Overview: Production error in version 1.0 harnesses; The immobilizer wire (orange/black) is in pin position #4 instead of pin position #5. Although an effort to correct the issue was made, some quantity of harnesses did get shipped before the issue was spotted. We are advising to inspect the harness BLADE connector before attempting to install harness or program the module. This issue is not known to affect the version 2 harnesses, which require no modification.

MODIFICACIÓN REQUERIDA PARA APLICACIONES A/T, SÓLO CON ARNÉS v 1.0

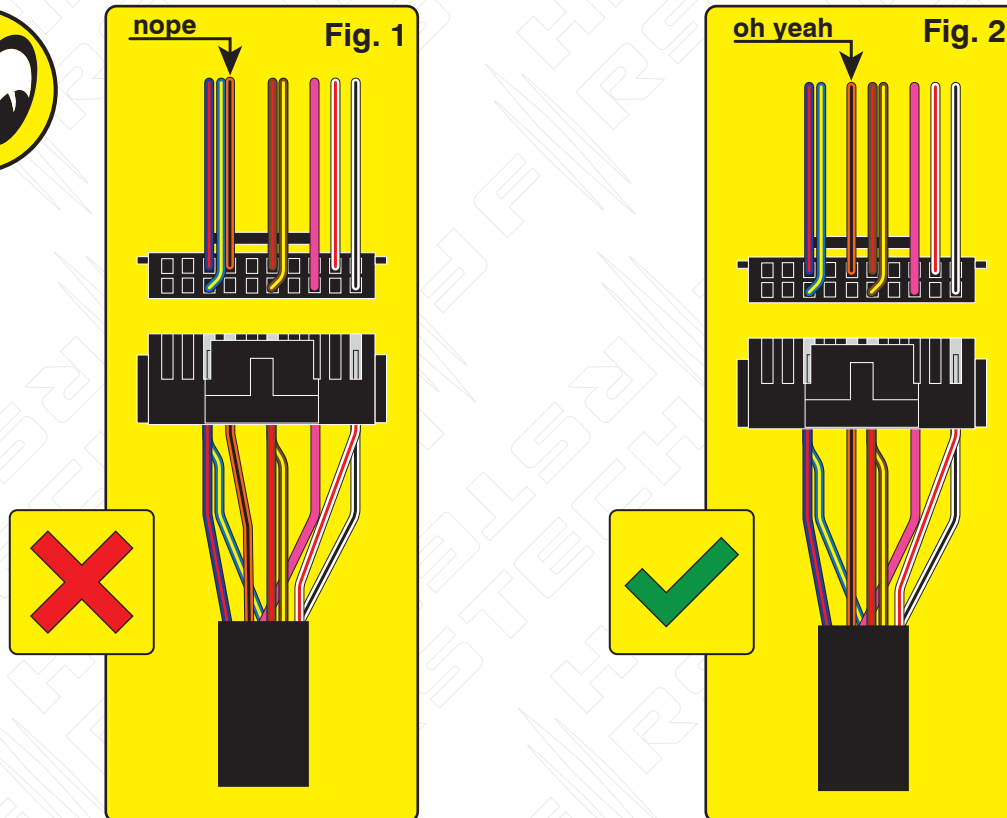
Issue: Module fails to program correctly to vehicle, does not allow the vehicle to be remote started.

Correction: Step 1.) Locate the orange/black wire and confirm whether it is positioned as illustrated in Fig. 1 or Fig. 2. If the wire is as illustrated in Fig.1, proceed with Step 2 through 5 and complete the repair procedure outlined, if the wire is as illustrated in Fig. 2, correction is not necessary, proceed with harness installation and module programming.

Step 2.) Using a pick, lightly depress the catch that secures the terminal in the housing then remove the wire and terminal from the housing.

Step 3.) Using a fine tip razor or utility knife, insert the blade beneath the terminal catch and raise it slightly, so that it can be reused to secure the terminal when reinserted into the BLADE connector housing.

Step 4.) Refer to Fig. 2 for correct position of the orange/black wire (next to brown/red) then reinsert the terminal, pressing lightly until the catch 'snaps' into place, securing the terminal in the connector housing.

Step 5.) The repair is complete, proceed with installation and programming.

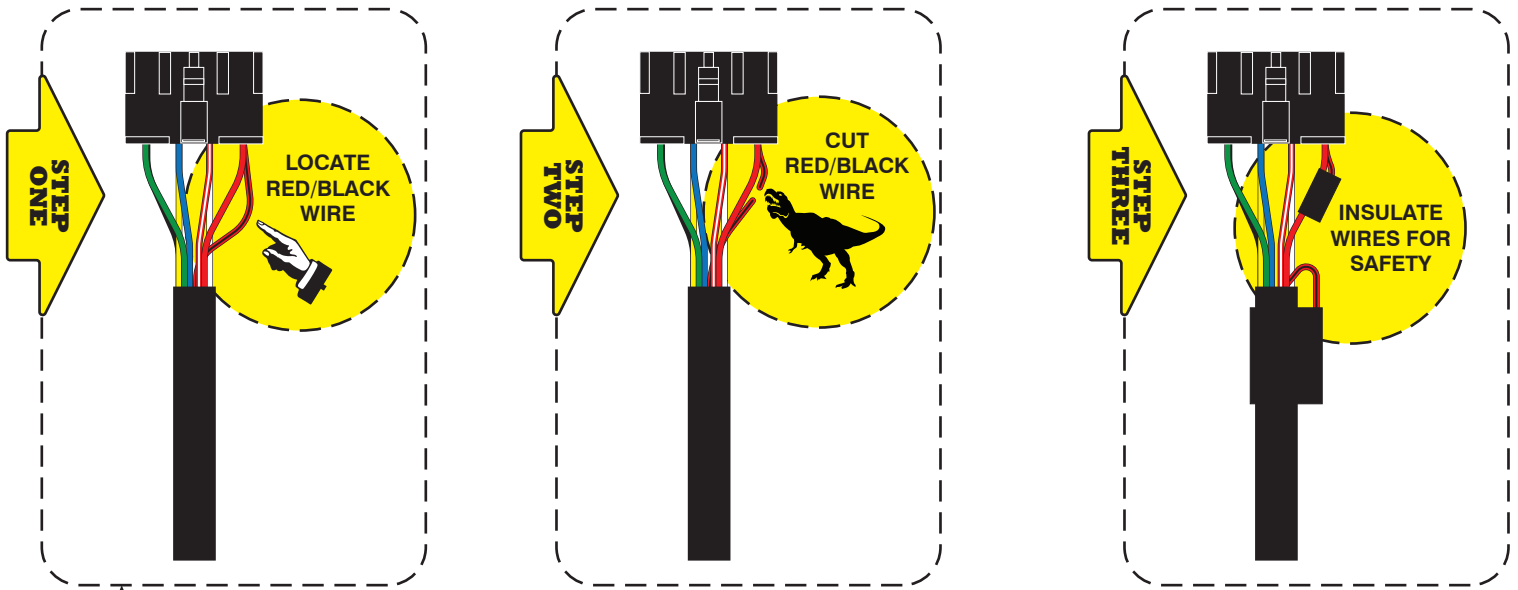
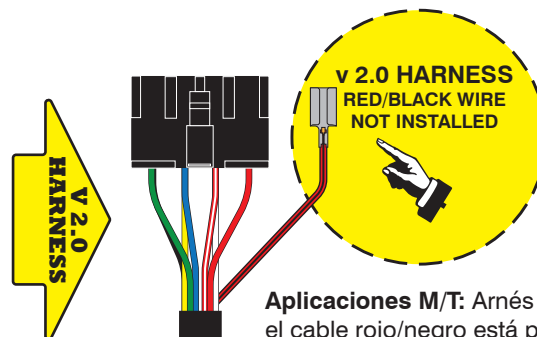
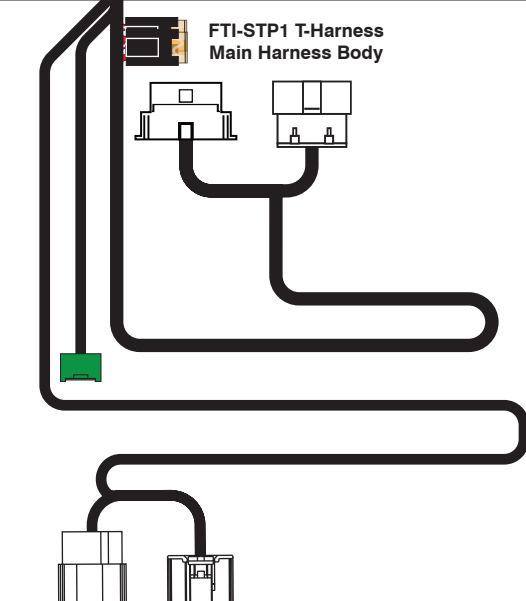
Descripción general: Las primeras versiones del arnés FTI-STP1 requieren modificaciones para aplicaciones de transmisión automática (AT), algunas del producto se pudo modificar antes del lanzamiento, pero una pequeña cantidad se lanzó sin modificaciones.

Problema: El arnés en T FTI-STP1 ha sido diseñado para ser compatible con A/T (transmisión automática) y M/T (manual transmisión), pero debido a un descuido en las primeras ejecuciones de producción, la selección se estableció por defecto en el modo M/T.

El uso de un arnés configurado para una aplicación M/T, en un vehículo equipado con A/T, podría provocar daños en el módulo del vehículo, se recomienda que el arnés vuelva al modo A/T antes de la instalación en vehículos equipados con transmisión automática.

Corrección: Localice el cable rojo/negro (+ embrague) proporcionado en el conector CN1 del conjunto del arnés principal. Corte el cable rojo/negro, ya sea al ras del conector CN1 o dejando suficiente cable expuesto para que pueda aislar y asegure los extremos del cable que quedan después del corte. Aísle cada uno de los extremos restantes del cable rojo/negro y asegúrelos para evitar cualquier posibilidad de cortocircuito. Si el cable rojo/negro ya ha sido desconectado, ninguna modificación adicional se requiere para aplicaciones A/T

NO SE REQUIERE MODIFICACIÓN CUANDO SE UTILIZA FTI-STP1 (v 1.0) ARNÉS EN APLICACIONES M/T, O CUANDO UTILICE EL ARNÉS FTI-STP1 (v 2.0)

Aplicaciones M/T: Arnés versión 2.0, el cable rojo/negro está pegado al arnés principal cuando se envía, y debe instalarse en el CN1 conector cuando está instalado.

Aplicaciones A/T: Deje el cable rojo/negro pegado al arnés, no es necesario para aplicaciones A/T
